OLD PALM CITY NAC DECEMBER 16, 2019

I. TITLE: Request for alternative compliance at 1299 SW 34th Street, by the property owners Lloyd and Debbie Rogers, represented by Bradley Currie, EDC, Inc.

PROJECT NARRATIVE & COVER LETTER ALTERNATIVE COMPLIANCE APPLICATION Rogers Palm City Property Palm City Lot 18 Block 51

STATE OF FLORIDA SHEET LI OF I

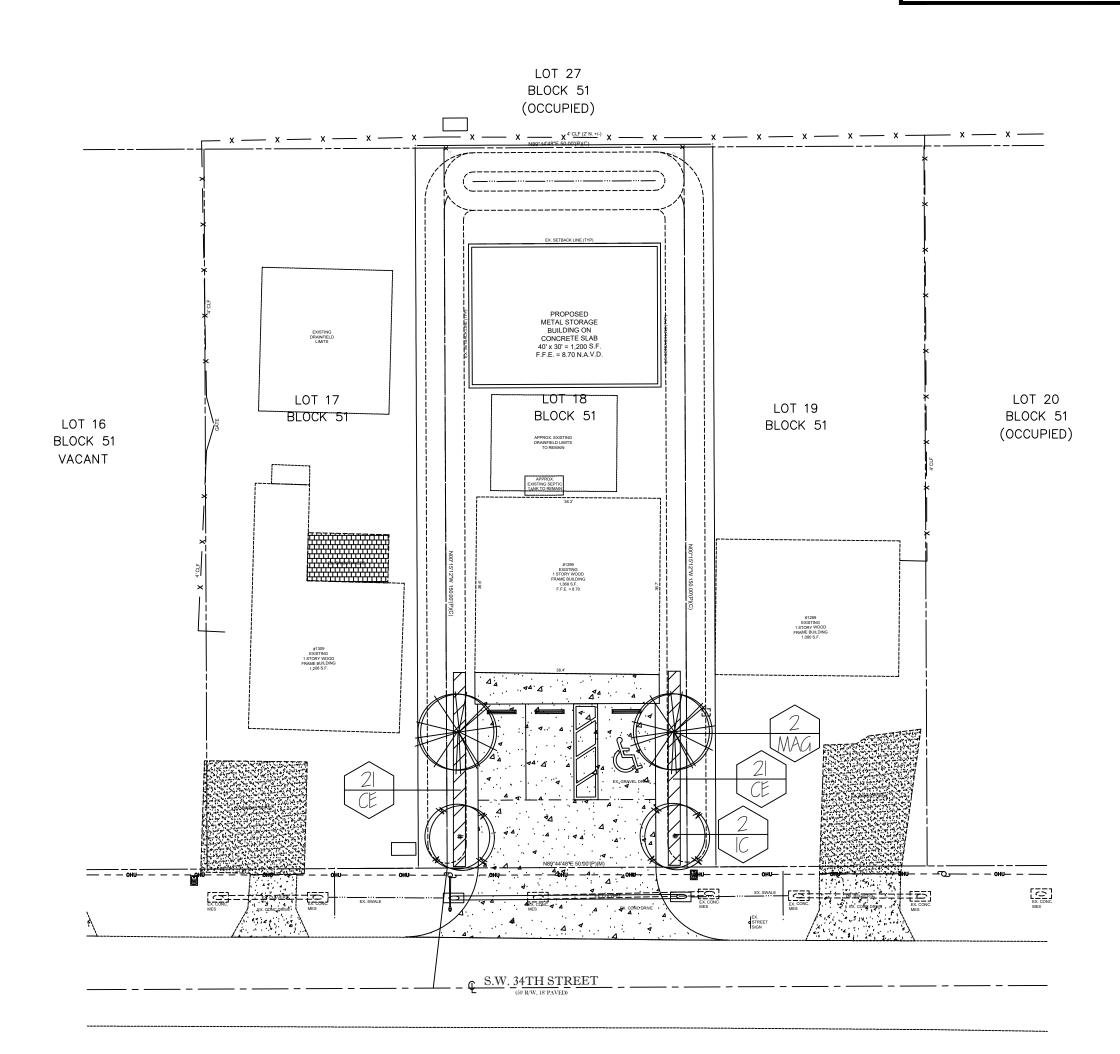
5. Plant four trees whereas Section 3.265.I.3. requires five trees (one tree per 1,500 sq. ft. of site area).

The proposed landscaping plan provides magnolias, dahoon holly, and green buttonwood on each side of the parking area. There appear to be other possible locations on the property for the additional required tree, such as in the vicinity of the southeast and southwest corners of the new storage building, which would also soften the appearance of the building.

Staff recommends denial of the request for alternative compliance to plant 4 trees rather than 5.
